Social Housing Renewal Standing Advisory Committee Debney's Precinct, Flemington

Report No 2

Report No 2 - Debney's Precinct, Flemington

Figure 3: Framework Plan from the Debneys Precinct Structure Plan

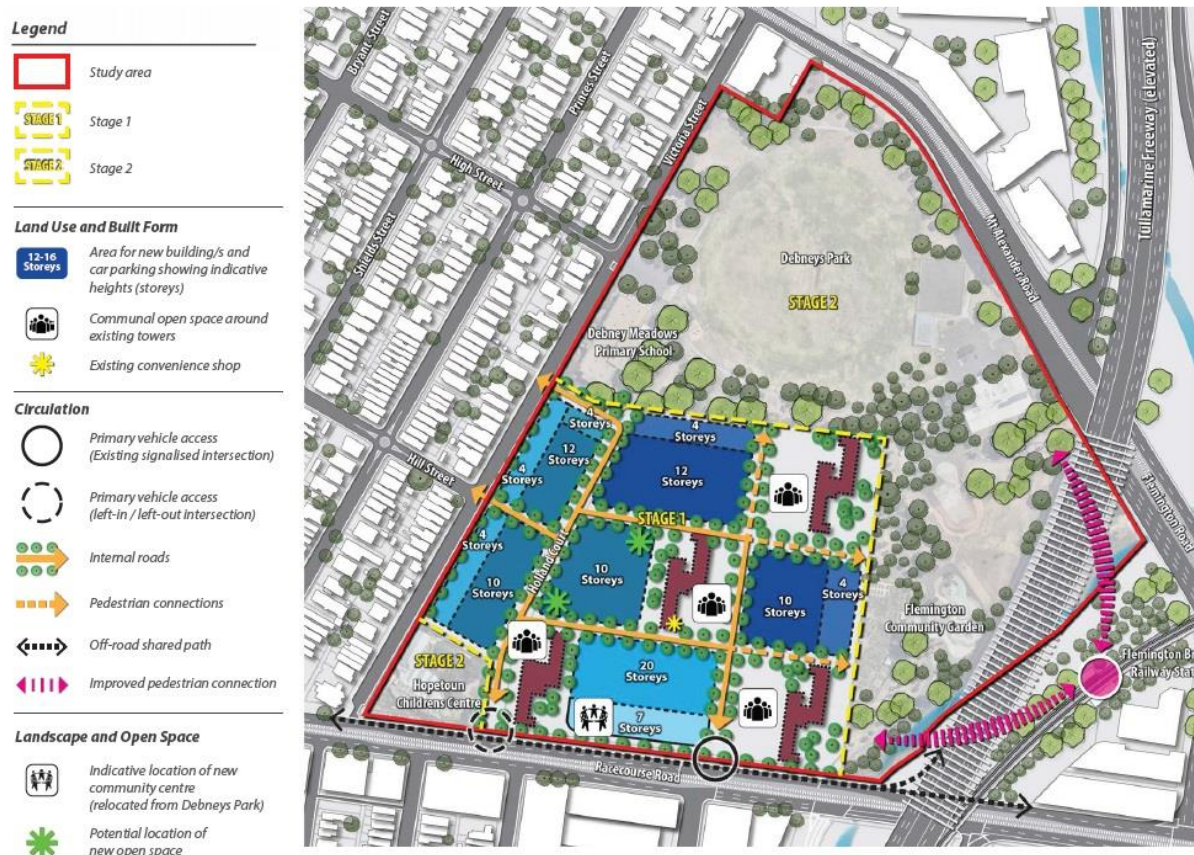
Before the Structure Plan is included in the Scheme, the Framework Plan will need to be updated to be consistent with the updated DPO8, including the updated Concept Plan.

- 2. Update the Framework Plan in the Debneys Precinct Structure Plan to be consistent with the updated Development Plan Overlay Schedule 8.**
- 3. Amend Clause 21.06-7 of the Scheme to include the following additional dot point:**

Concept Plan (Note: include Concept Plan, legend and table as an integrated document)

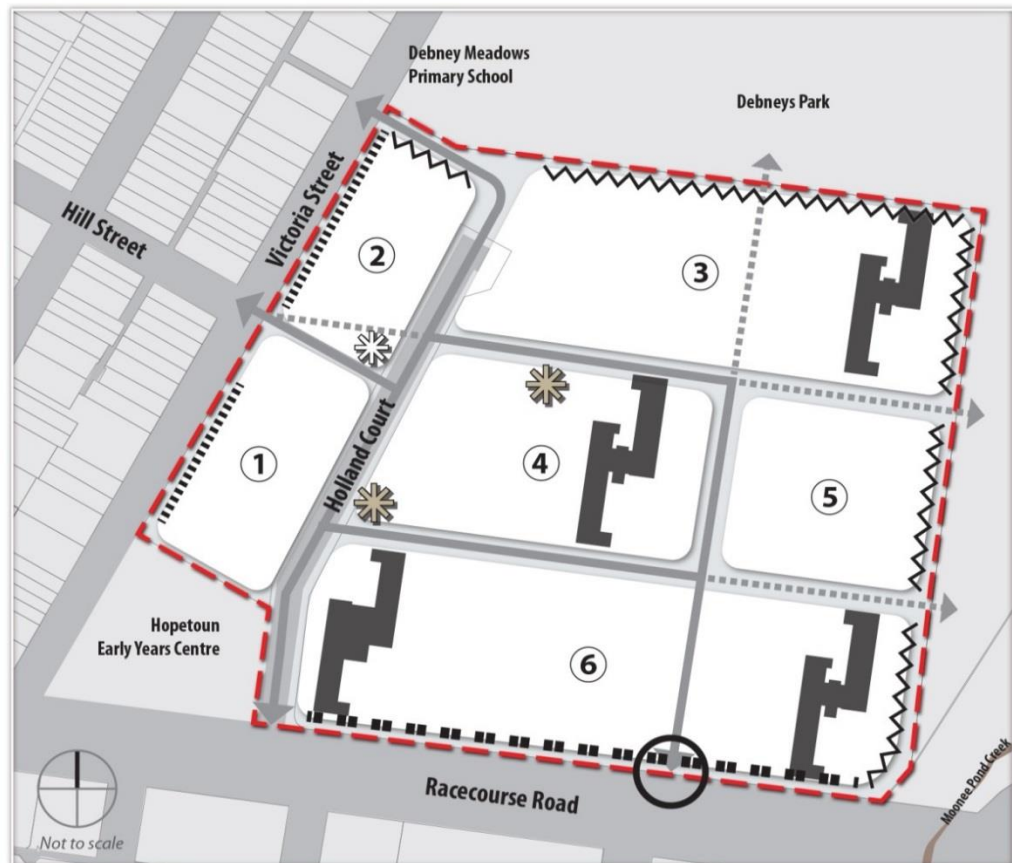
The Committee supports Mr Sheppard's suggestion that the Hill Street extension should be more effectively linked to the proposed northern east-west road. It agrees that a visual connection can be established by inserting a wedge-shaped pocket park to the north of the intersection. This has been included in the revised DPO8.

Council sought to reposition the controlled intersection opposite Stubbs Street to directly align with Stubbs Street. The Committee endorses this proposal. The resulting street alignment (which is slightly to the west of that shown on the Concept Plan) would retain a visual connection to the park to the north, while at the same time reusing existing pavement areas adjacent to the high-rise tower, minimising disturbance to the existing tree line to the east and reducing the space occupied by roadway at the intersection.

Council submitted that the roadway shown in the Concept Plan along the southern boundary of the school site, linking Victoria Street to the northern extension to Holland Court, should be removed, allowing additional play space to be provided in this area for the school and/or the Estate. The Committee does not support its removal. Not only does it reinforce the neighbouring street pattern, but it allows an alternative access point for residents of the Estate, and would be useful if the community garden formed part of Precinct 3.
